Access Compliance Report

Public Rights-of-Way

(Curb Ramps)

Intersection ID: 30271	Main Street: FORTESCUE_DR	Cross Street: RAVANNA_DR	Location: E
ADA ID: F7D63E832A4A	Ramp Type: PerpDiag	Initial Pass/Fail: Fail	Overall Compliance: No
Severity Score: 25			
Codes/Mitigation Info/Possible Solution		Field Measurements/Component Compliance

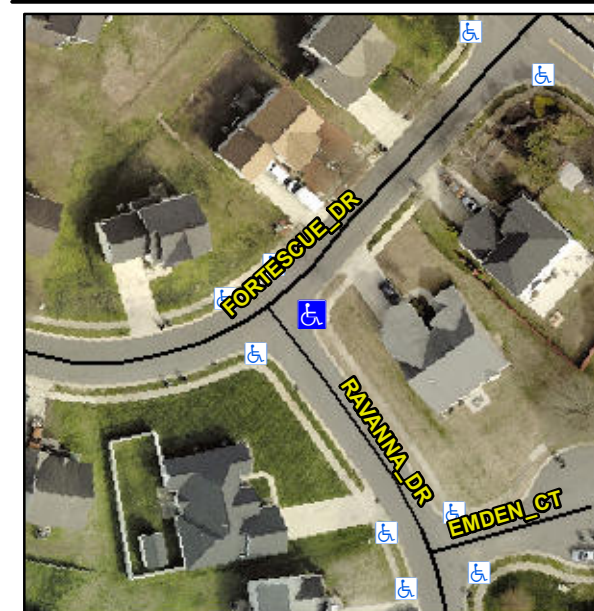
Not Found, R304.5.3

Compliance	Description	Data	Compliance	Description	Data
N/A	Ramp Length (in)	46.0	Yes	Ramp Slope (%)	8.3
Yes	Ramp Width (in)	48.0	No	Ramp XSlope (%)	7.6
N/A	Flare Type LT	N/A	N/A	Flare Type RT	N/A
N/A	Flare Slope LT (%)	N/A	N/A	Flare Slope RT (%)	N/A
N/A	Flare Traversable LT?	N/A	N/A	Flare Traversable RT?	N/A
N/A	Landing Length (in)	N/A	N/A	DWS Provided?	N/A
N/A	Landing Width (in)	N/A	N/A	DWS Contrast?	N/A
N/A	Landing Slope (%)	N/A	N/A	DWS Length (in)	N/A
N/A	Landing X Slope (%)	N/A	N/A	DWS Full Width?	N/A
N/A	Landing Curb? (Y/N)	N/A	N/A	DWS Offset (in)	N/A
N/A	Shared Landing?	N/A			
N/A	Gutter Ponding?	N/A	N/A	Gutter Slope (%)	N/A
N/A	Gutter Lip Ht (in)	N/A	N/A	Gutter X Slope (%)	N/A
N/A	Painted X Walk1?	No	N/A	Painted X Walk2?	No
	X Walk 1 Direction	To N		X Walk 2 Direction	To S
N/A	X Walk 1 Width (in)	N/A	N/A	X Walk 2 Width (in)	N/A
	X Walk 1 Slope (%)	1.2		X Walk 2 Slope (%)	6.5
	X Walk 1 X Slope (%)	7.1		X Walk 2 X Slope (%)	1.9

Remove & Replace Curb Ramp With Two New Directional Ramps or Equivalent.
